***Pittsfield/Housatonic River Site, On-Plant  
Consolidation Areas - Addendum to June 1999  
Detailed Work Plan, August 12, 1999***

Re: Pittsfield/Housatonic River Site,  
On-Plant Consolidation Areas -  
Addendum to June 1999 Detailed Work Plan

FIGURE **3**

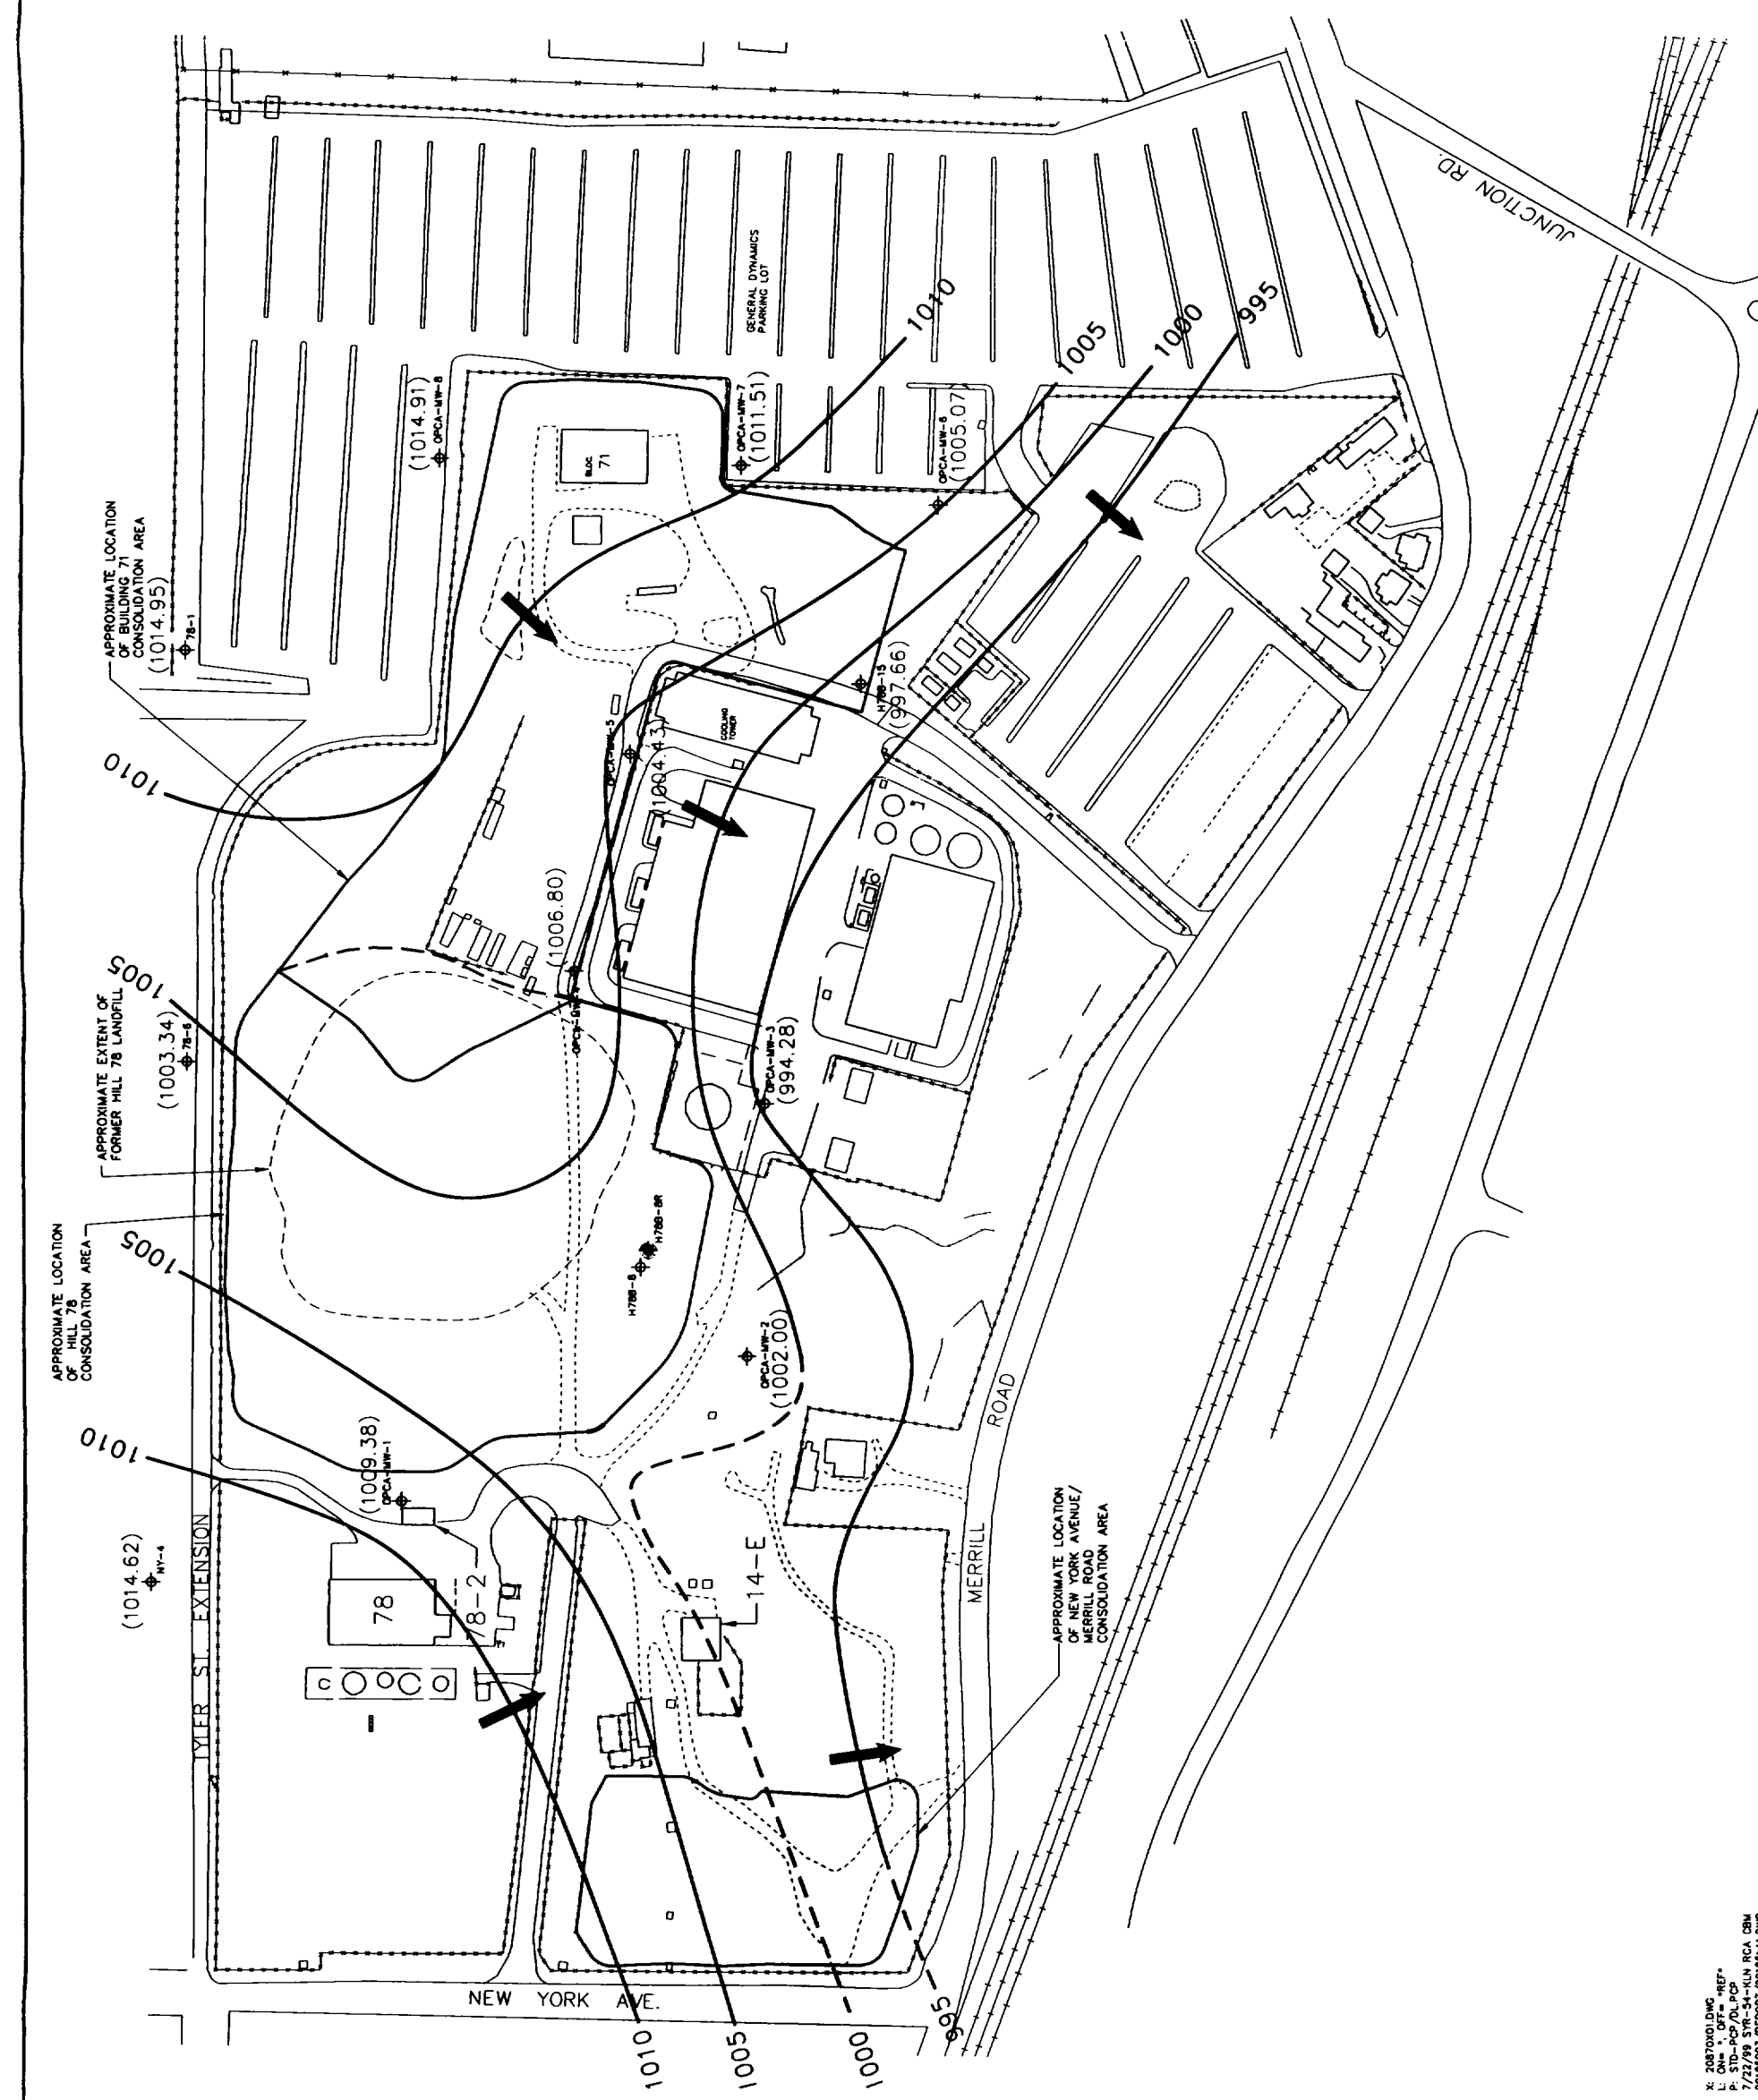
*Include a figure (or two) that depicts the overburden and bedrock water table maps. Also, include a figure identifying the till elevation contours beneath the Consolidation Areas.*

## ***Revised Work Plan Figure 1***

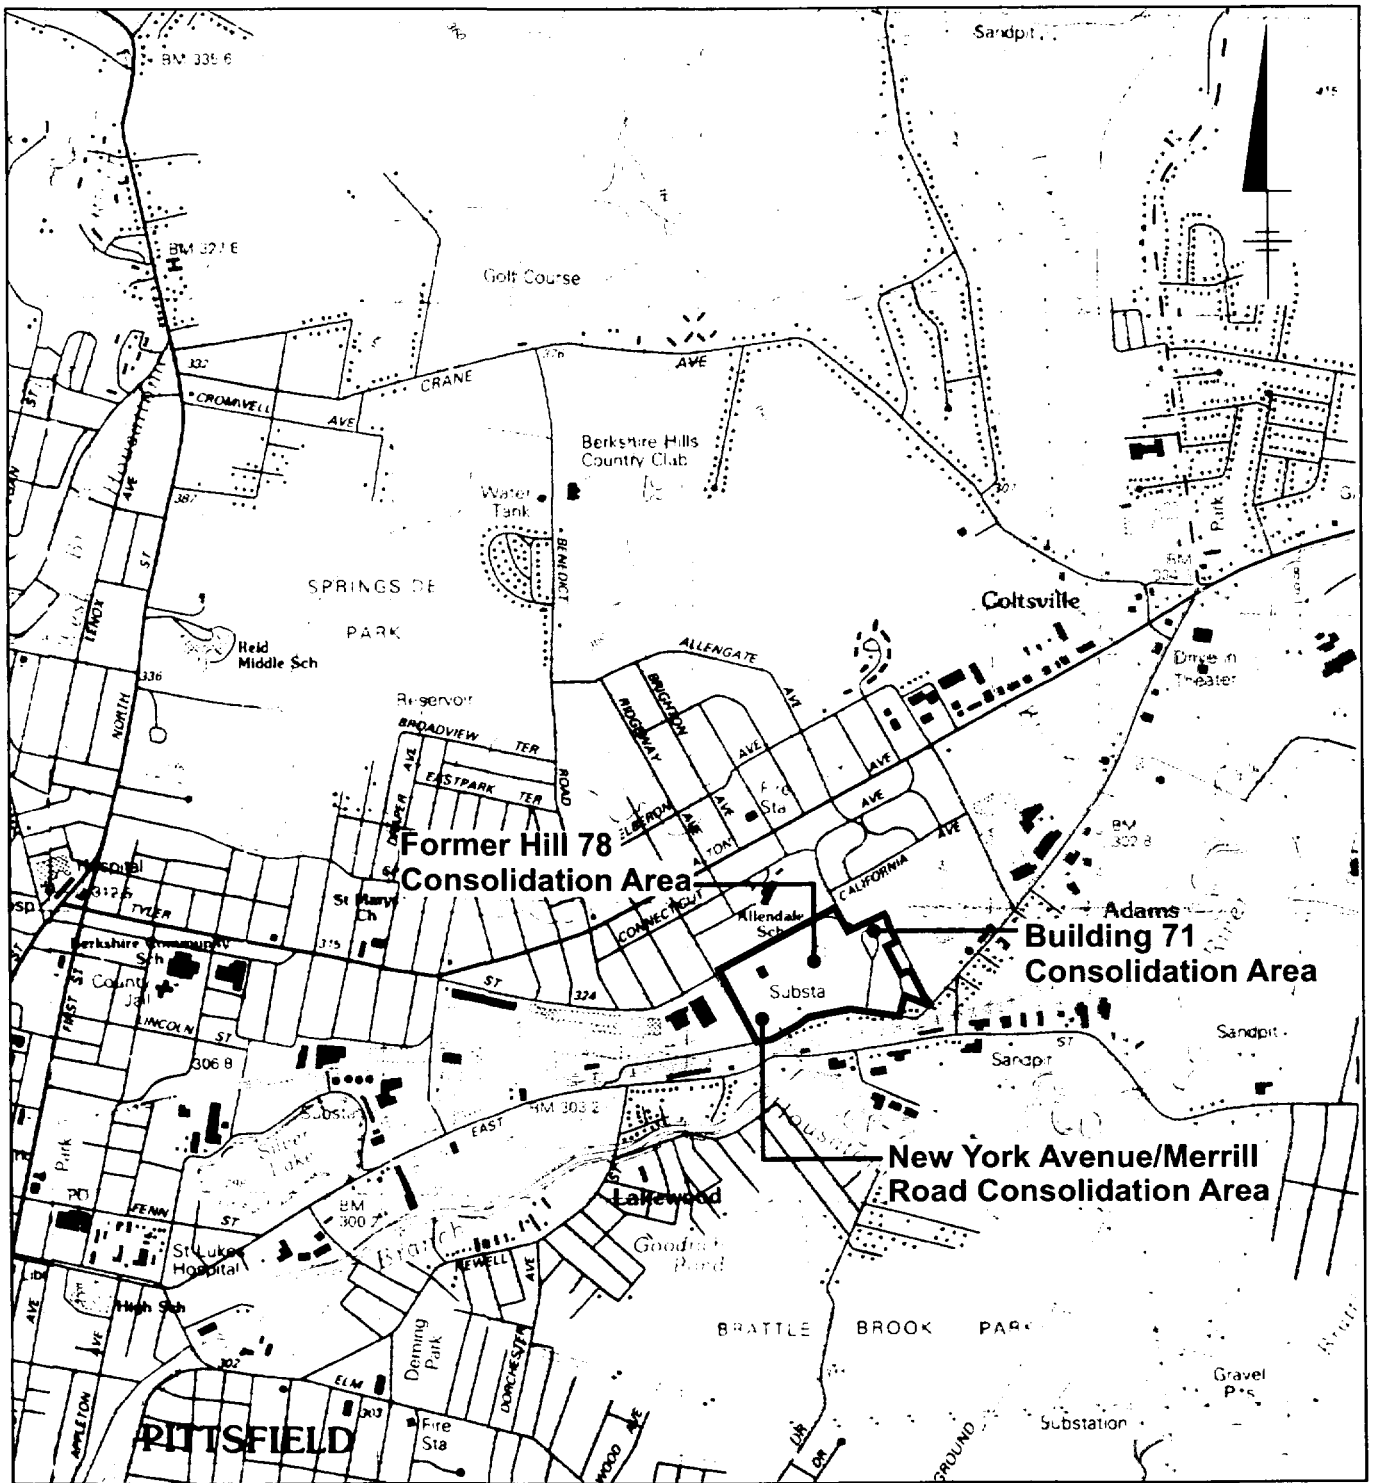
*Figure 1: The Site Location Map does not identify the facility per the definition of the CD.*

A revised Figure 1 is included as Attachment J to this Addendum.
